Service Bulletin

Replacement of UniPoint SNLS-135 starter solenoid with Lamar STS-S12 starter solenoid.

SB-GA8-2019-197	Issue 1	Date of Issue: 5 November 2020	Page 8 of 12
-----------------	---------	--------------------------------	--------------

Figure 3 – Solenoid box with SNLS-135 starter solenoid prior to modification

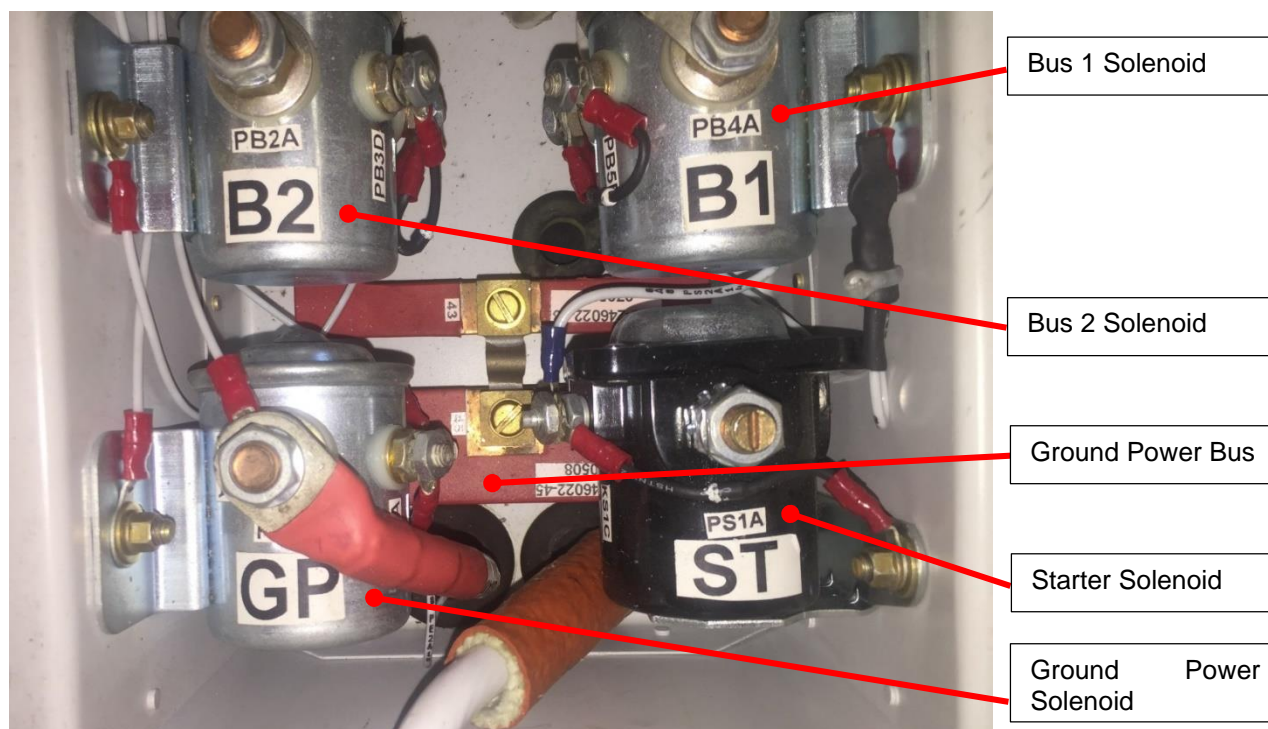
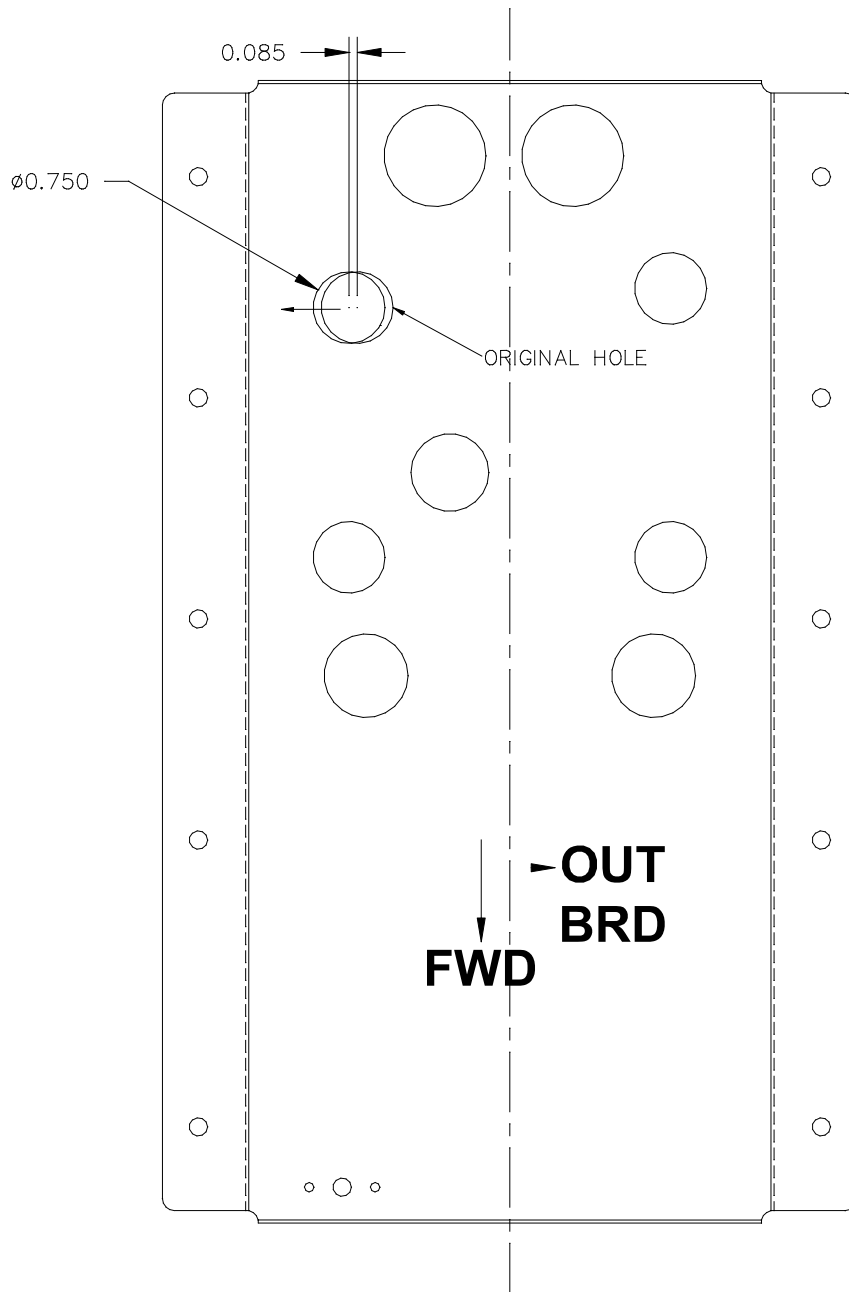
- 1.3.1 Remove the starter solenoid marked “ST” in Figure 3.
- 1.3.2 Remove the ground power solenoid marked “GP”. This will be re-inserted later.
- 1.3.3 Remove the GP ground power bus as noted in Figure 3. This will be modified as described later in this Service Bulletin.

Figure 4 – Side view of unmodified solenoid box (Starter and Bus 1 solenoids).

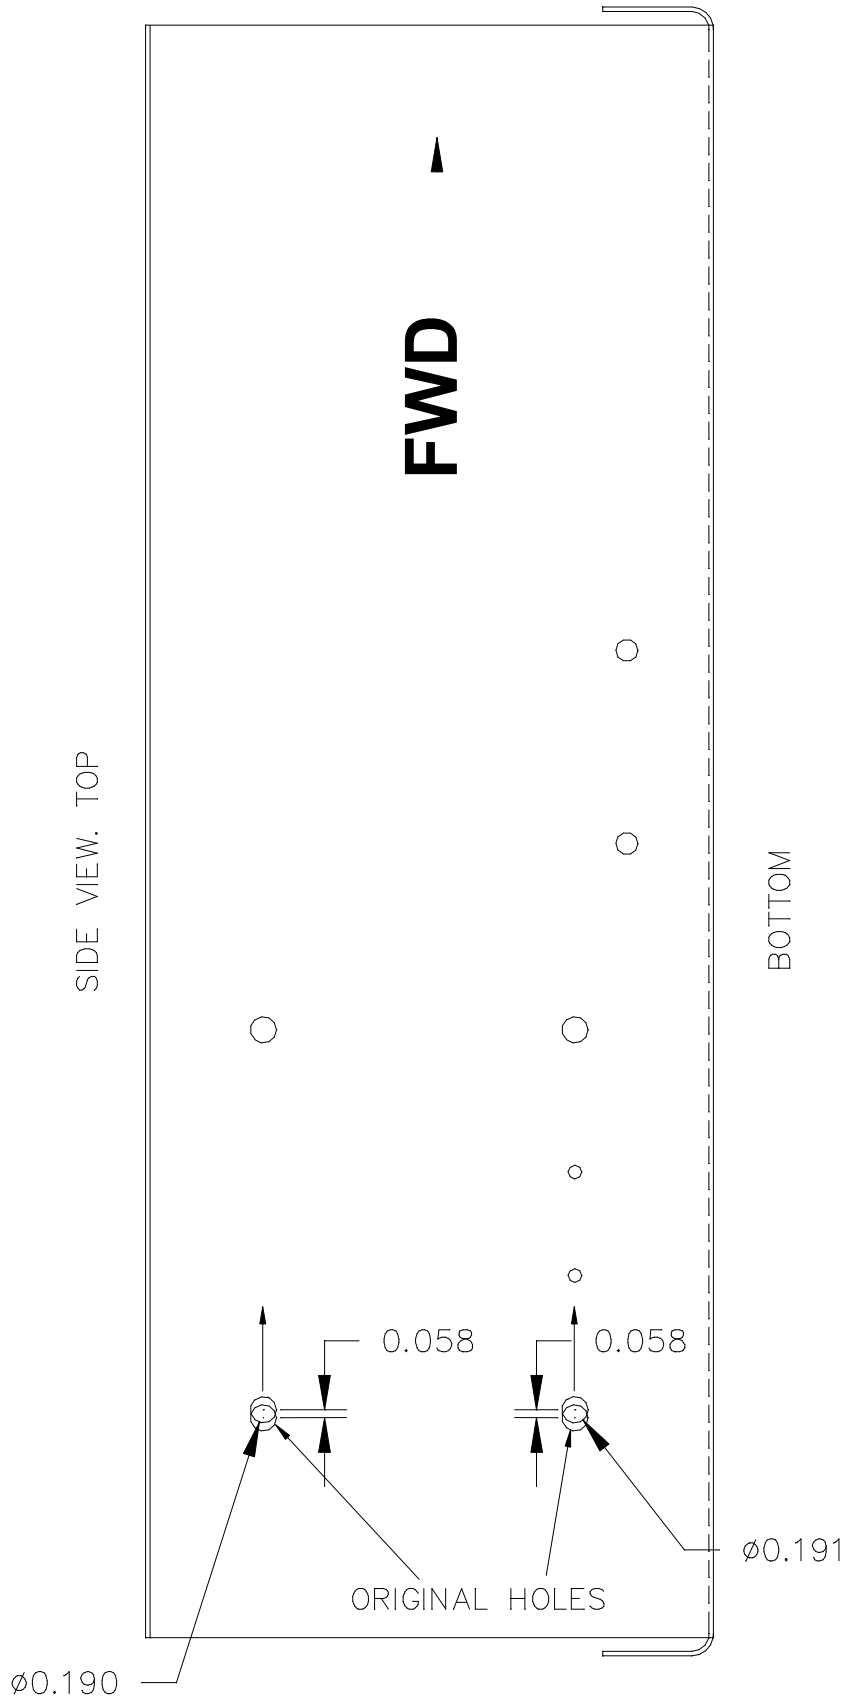
- 1.3.4 The lower fasteners for the Bus 1 and Starter solenoids are secured with an anchor nut retainer. This is to be replaced with Item 2.
- 1.3.5 De-rivet the anchor nut retainer as indicated by arrows in Figure 4. This is on the inboard side of the solenoid box.
- 1.3.6 Elongate the hole in the base of the solenoid box as shown in Figure 5.
- 1.3.7 Elongate the two holes in the starter solenoid side of the box as shown in Figure 6.
- 1.3.8 Restore surface protection to holes using Compound C1 (Table 3).
- 1.3.9 Replace retainer with Item 2 using rivets Item 7. Orient rivet heads to the outside of the box as shown in Figure 4. Note that Item 2 is **not** symmetric about the rivet holes and correct orientation must be confirmed before riveting.

**Figure 7 – Un-modified GP Start Bus
(Oriented as shown in Figure 3)**

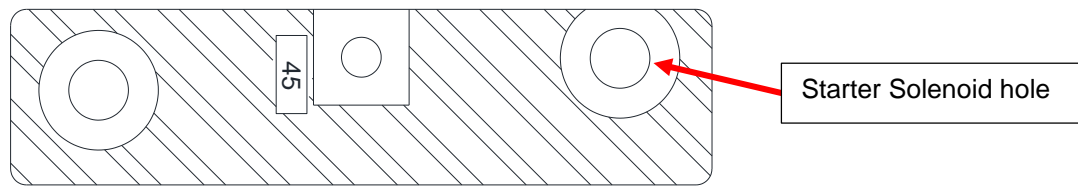
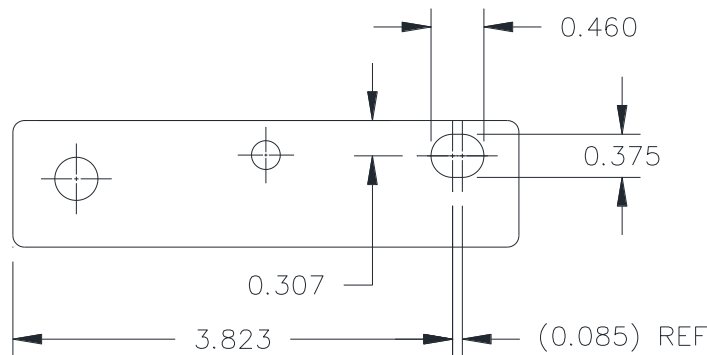
- 1.4.1 The GP Start Bus bar is located below the Ground Power and Starter Solenoids. The hole used to secure the starter solenoid is to be elongated by 0.085”.

Figure 10 – Modified wiring (partial)

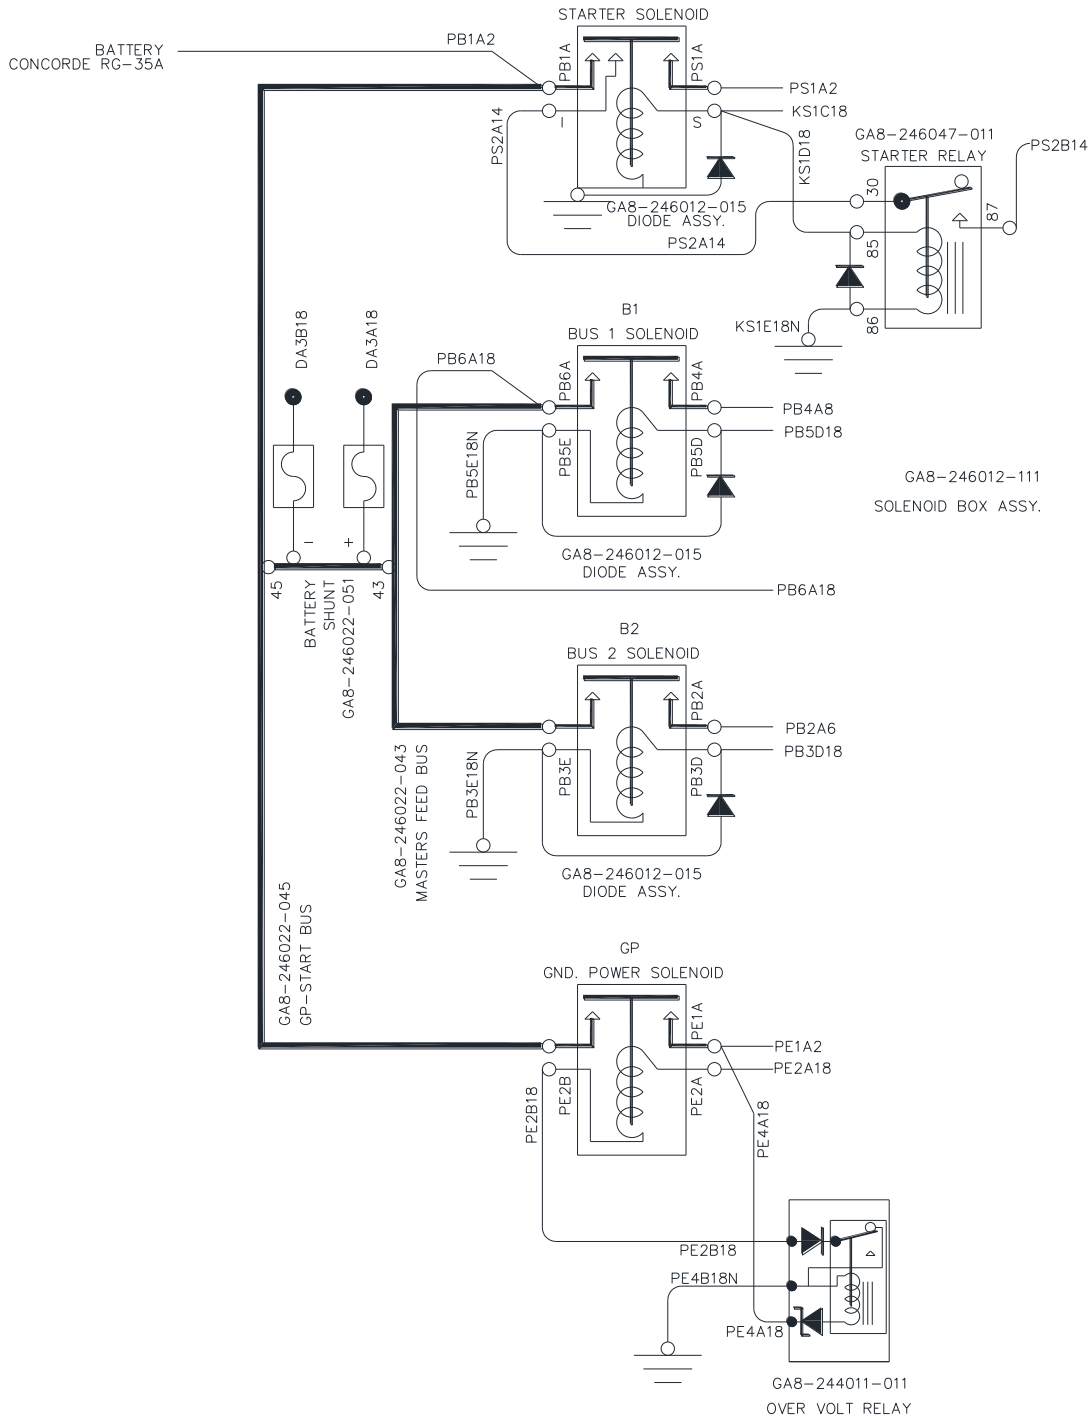
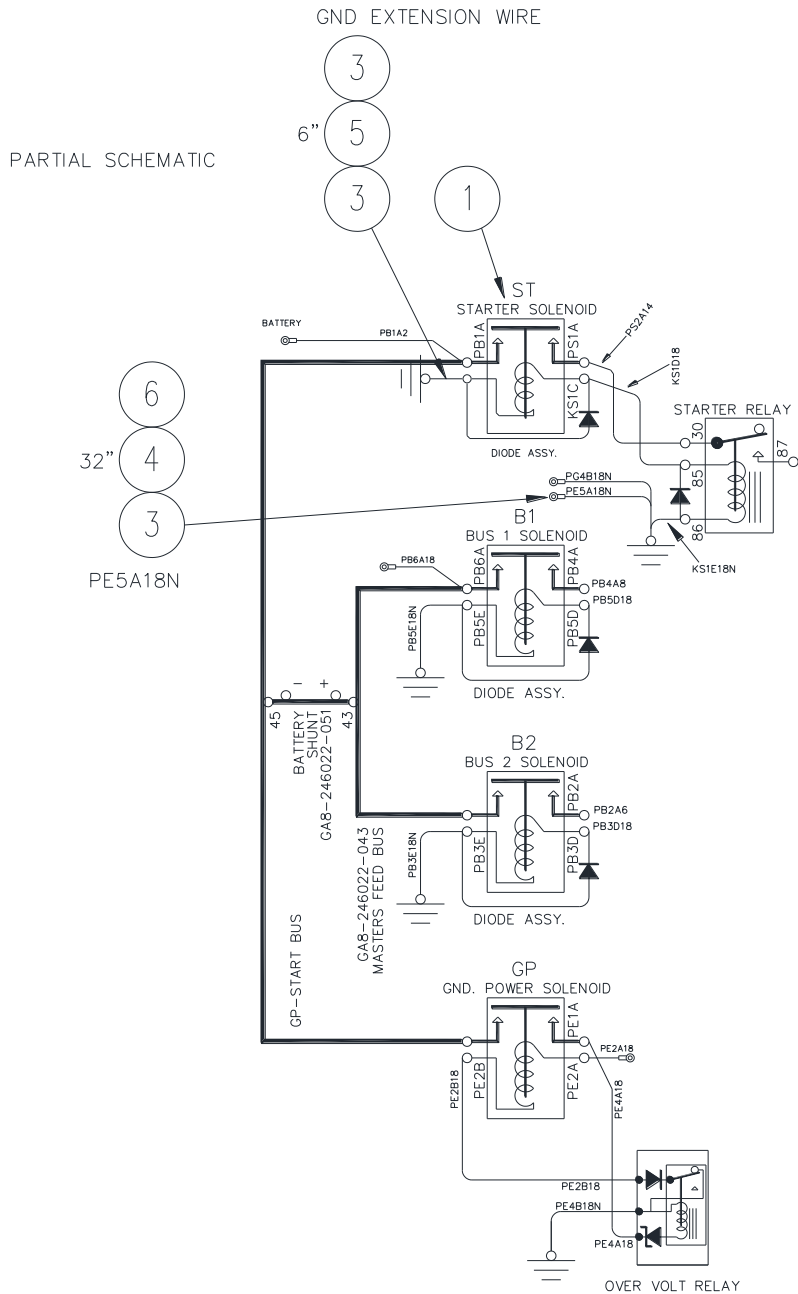
- 1.5.3 Install the solenoids and bus bars to the solenoid box.
- 1.5.4 The original wiring in the solenoid box is given in Figure 24-1 “Power Distribution Schematic” of the GA8/GA8-TC 320 Service Manual. The modification to be made is shown in Figure 10. Figure 9 and Figure 10 are a partial view of the entire wiring made within the solenoid box. Figure 9 is a close-up view of the wiring associated with the starter solenoid.

- 1.5.5 For a four-stud solenoid, an earth wire link is required between the starter solenoid coil negative terminal and the earth point on the box. The supplied wire assembly is too short and is to be replaced with Items listed in Figure 10 for the “GND EXTENSION WIRE”.

Figure 11 – Side view showing earthing point for starter solenoid to the box.

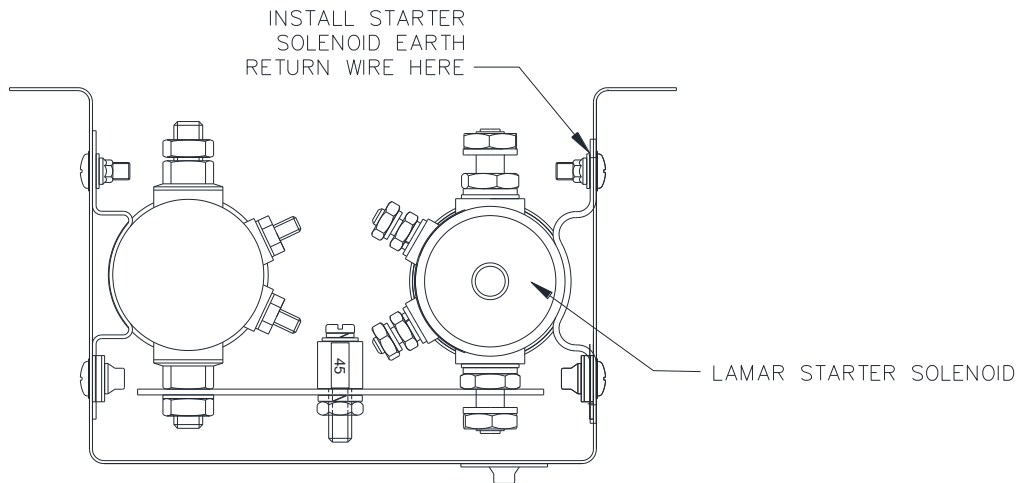
- 1.5.6 This wire shall be placed in the locations as directed by Figure 11 & Figure 12.
- 1.5.7 An additional earth wire is installed which has been denoted PE5A18N. Install this to the solenoid box as noted in Figure 13. The other end of this wire will be terminated after the solenoid box has been re-installed in the aircraft.

Figure 12 - Location for placement of solenoid starter earth return.

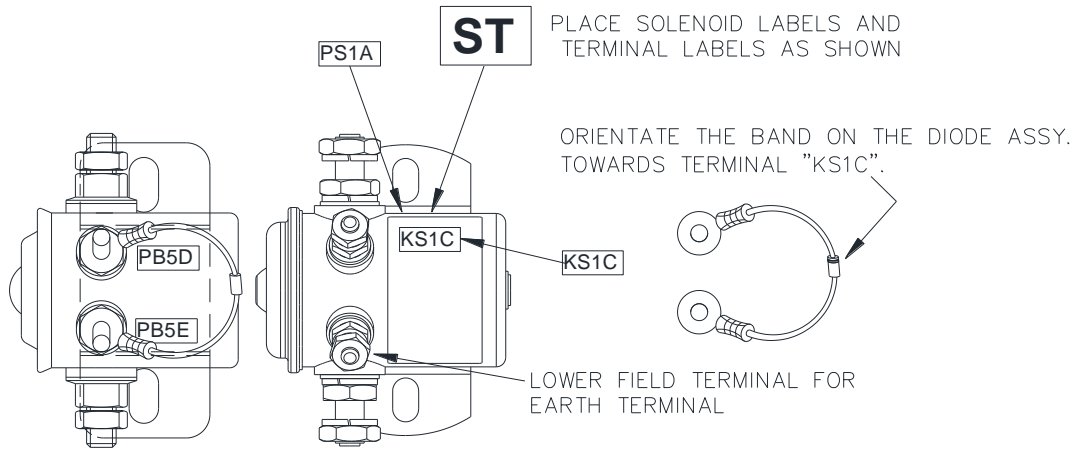
- 1.5.1 If a three-stud solenoid is supplied, electrical connections are made to the solenoid case in lieu of the coil negative (-) terminal.
- 1.5.2 Fabricate and apply labels to the Starter Solenoid as shown in Figure 12 & Figure 13. Alternately, the part may be marked directly using indelible means.

Figure 14 – Termination point for circuit PE5A18N

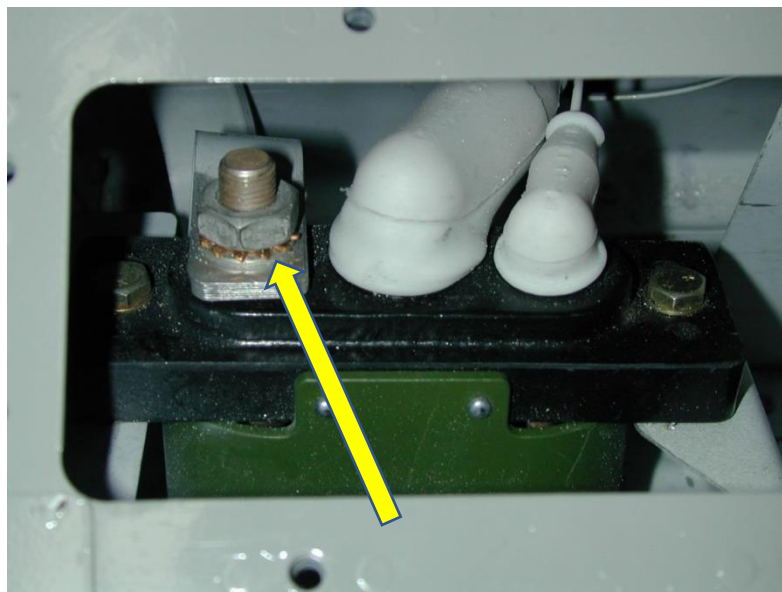
- 1.5.10 Return all previously disconnected wires to their original locations.
- 1.5.11 Re-install the solenoid box into the aircraft floor. If removed in Section 1.2, also re-install the battery box.
- 1.5.12 Connect circuit denoted PE5A18N to the ground power earth point per Figure 14.
- 1.5.13 Inspect the wiring to ensure that all terminals are secure.
- 1.5.14 Inspect the solenoid box for security and remove any debris.
- 1.5.15 Re-connect the Circuit Breaker Panel Assembly, returning all previously disconnected wires to their original locations and re-install the Circuit Breaker Panel Assembly.
